Summary of Items Discussed in 1/2018 APSEC Discussion Forum on 19 January 2018

FOUNDATION LAYOUT PLAN

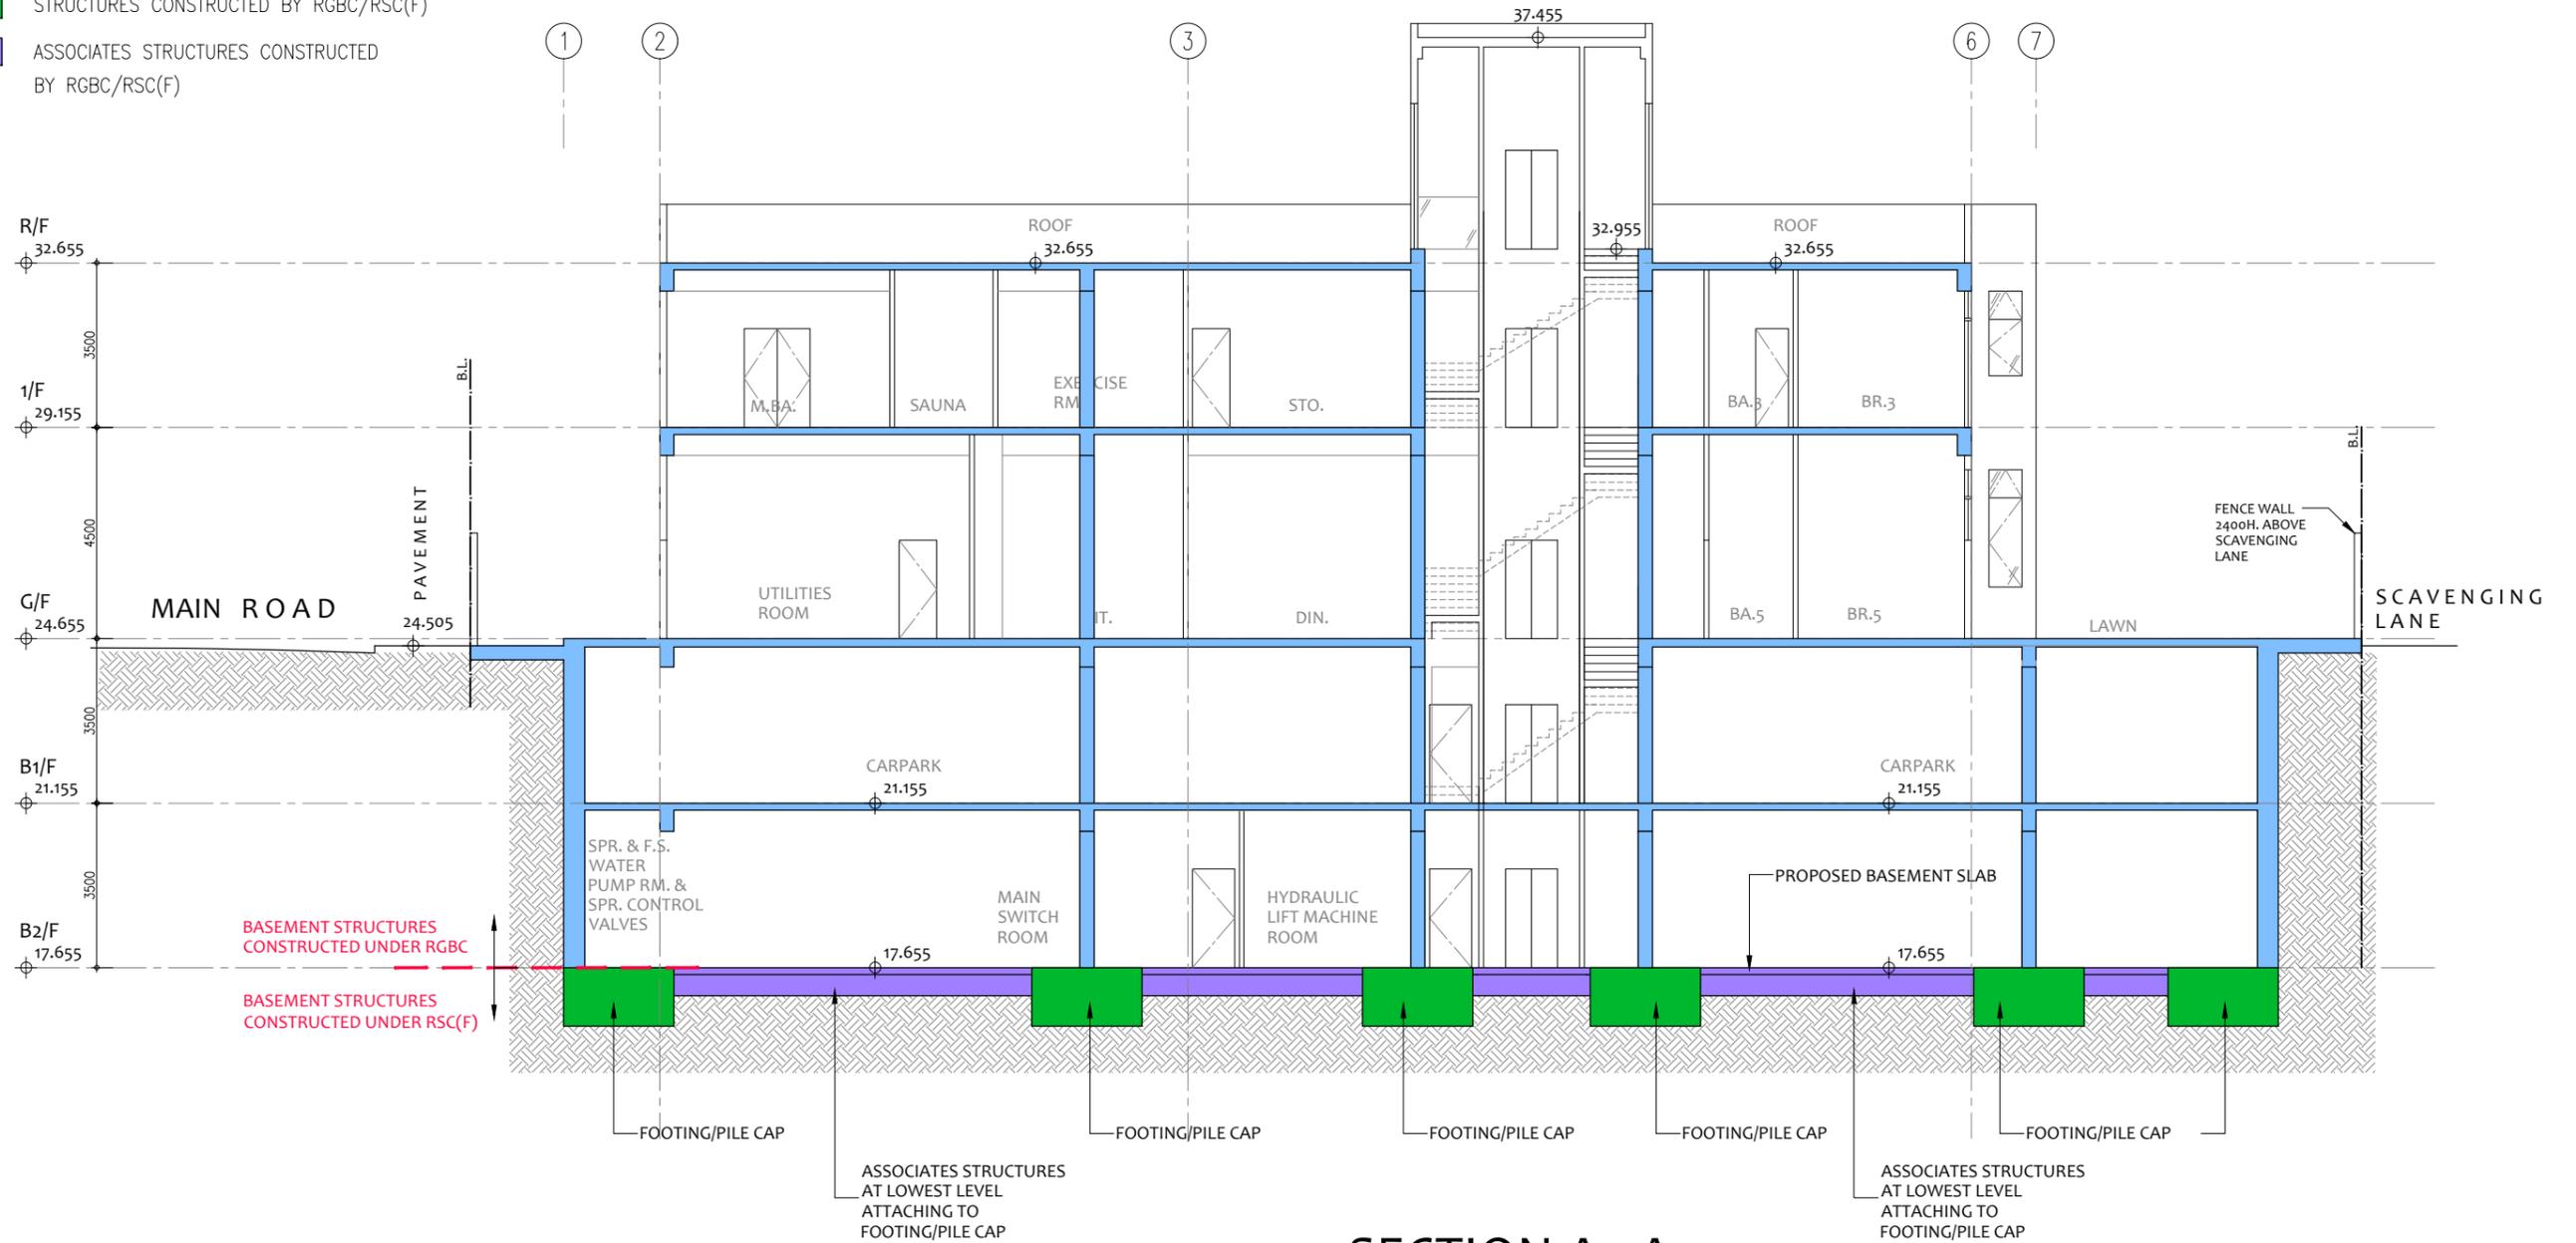
AOB Items	
11	<p><u>PNAP APP-96 - Registration of General Building Contractors and Specialist Contractors</u> (Item raised by HKIE)</p>

<p>Paragraph 10 of Appendix A of PNAP APP-96 states that “Basement works: Excavation for basements, construction of basement walls, slabs and drains, which do not form part of pile caps fall within the scope of works of the RGBC”. It is commonly understood that this is referred to basement works above the pile caps level, and the pile caps/footing could be carried out by RSC(F).</p> <p>It is very common that the lowest floor of basement structures (associated slabs and beams) are attaching to the pile cap/footing as so to minimize the volume of excavation for environmental friendly design and construction. As these slabs and beams will form an integral part of the base flooring for water proofing, these element shall be constructed together with the pile caps/footings.</p> <p>PNAP AAP-96 also says that AP/RSE/RGE are expected to make their professional judgment on selection of appropriate category of Registered Contractors for BA’s consideration (para. 9 of App A. refers). Therefore, we would like to clarify whether the RSC(F) could be appointed to carry out the associated structural slabs and beams which are attaching to the pile caps/footings to form an integral base of the basement.</p> <p>Attached please find the relevant PNAP and sketches of part plans and sections showing a typical basement structure including pile caps/footing and the attached slabs and beams.</p>	<p>BD advised that as the tie beams and individual caps/footings as shown in the attached plans formed an integral part of the foundation system, RSC(F) would be allowed to construct these beams and slabs. Other situations, such as raft and combined caps associated with basement beams and slabs, should be considered on case basis. Furthermore, such arrangement should be clearly indicated during consent application and relevant supervision requirements should be followed accordingly.</p>
